TRANS/WP.29/GRSP/2000/12
11 August 2000

PROPOSAL FOR DRAFT AMENDMENTS TO REGULATION No. 16
(Safety-belts)

Transmitted by the Expert from Japan

Attachment 1: .Surveys for reasons not to use safety-belts

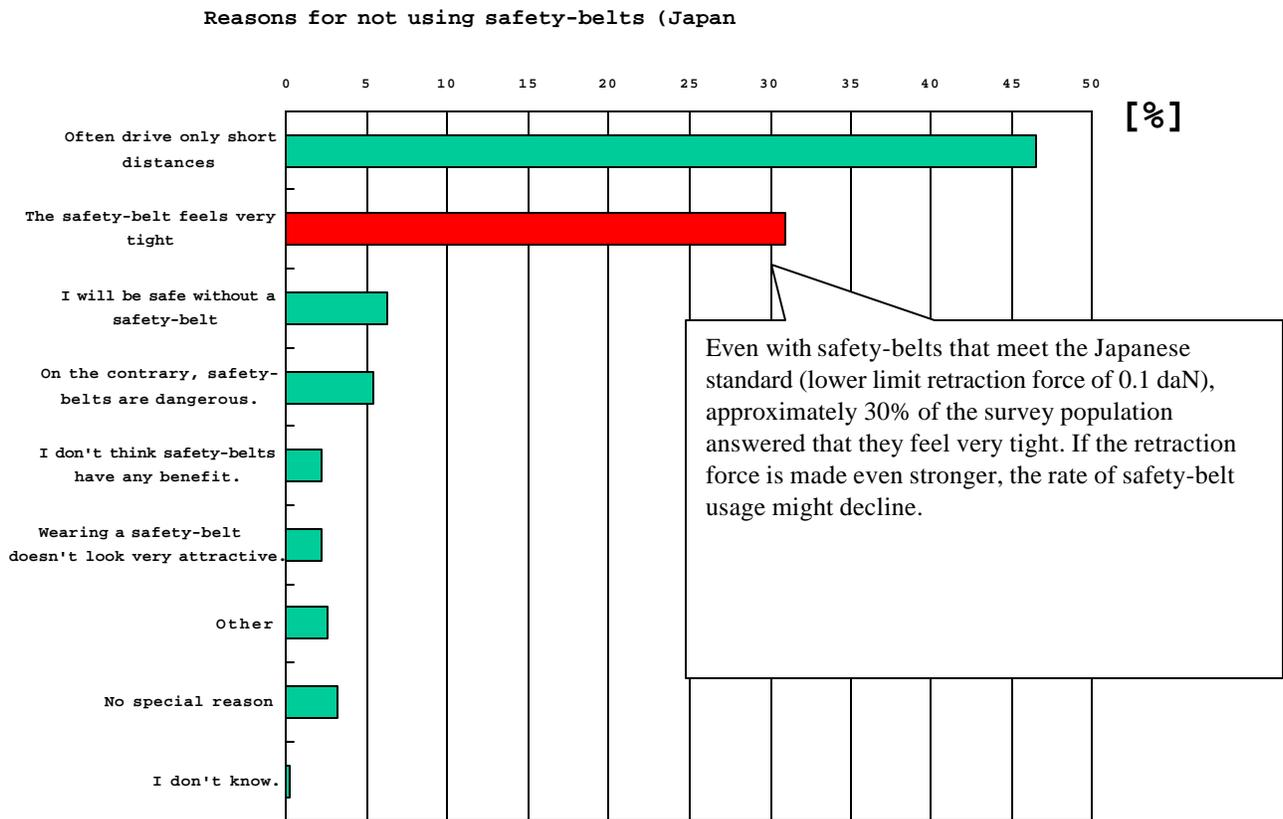
In the Japanese market, many passengers claim the reason for not wearing safety-belt as compressive force. (approximately 30 per cent, see attachment 1). It is feared that with even stronger retraction force than in the present Regulation, the rate of safety-belt usage might decline.
